A	04/20/12	RC	FOR APPROVAL	REVISION
NO.	DATE	BY		
 <b>STS STEEL, INC.</b> ENGINEERS • FABRICATORS • ERECTORS PH: (518) 370-2693 FAX: (518) 370-2696				
DRAWING TITLE <b>UPPER STEEL (U8-U10)</b>				
PROJECT No. US RT 2 BRIDGE No 24 FEDERAL AID No.				
ENGINEER: CHA				
CUSTOMER: Harrison & Burrowes Bridge Constructors, Inc.				
PROJECT: RICHMOND, VT - TRUSS BRIDGE REHAB				
RICHMOND, VT				
HOLE:	15/16" U.N.O.	PAINT:	PER SPEC	DATE: 03/16/12
BOLTS:	A325 U.N.O.	DRBY:	RC	JOB NO. 1156
WELDS:	AWS D1.5	CHKBY:	SG	DWG NO. 48

DATE 5/9/12 BY CHA PKR /dl

ONE REQ'D ~ Mk. M48B  
 LIFTING WEIGHT ? lbs  
 4 - sb7-24"  
 x35b B/S  
 x42d N/S  
 4 - sb7-24"  
 x35b B/S  
 10 - sb7-24"

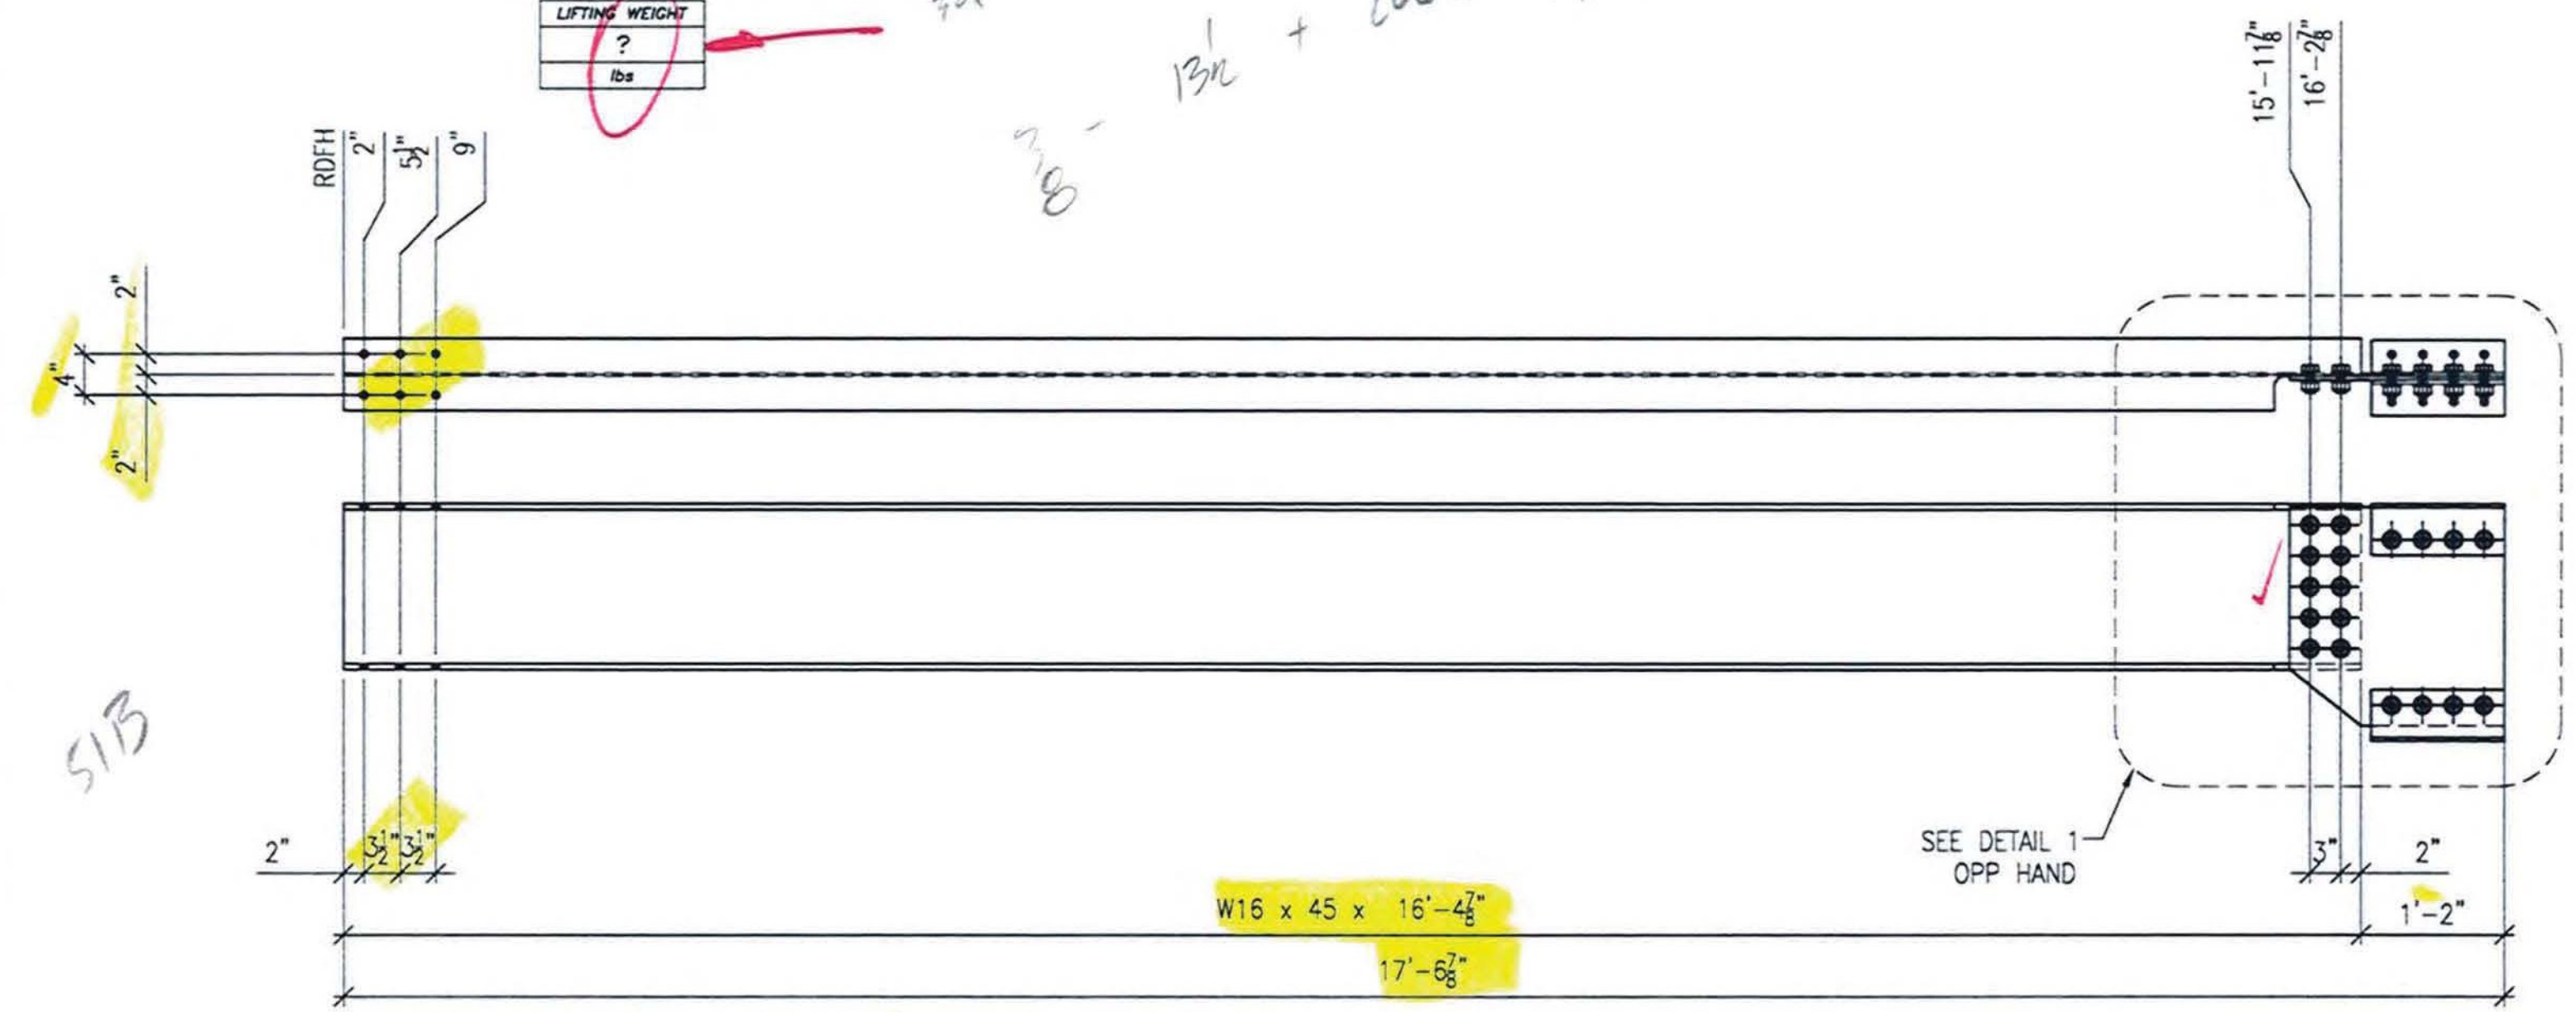
OVER ALL DEPTH OF TRUSS  
 1'-11 1/8" THE ORIGINAL DETAILS  
 HAD 1/4" OF ERECTION CLEARANCE
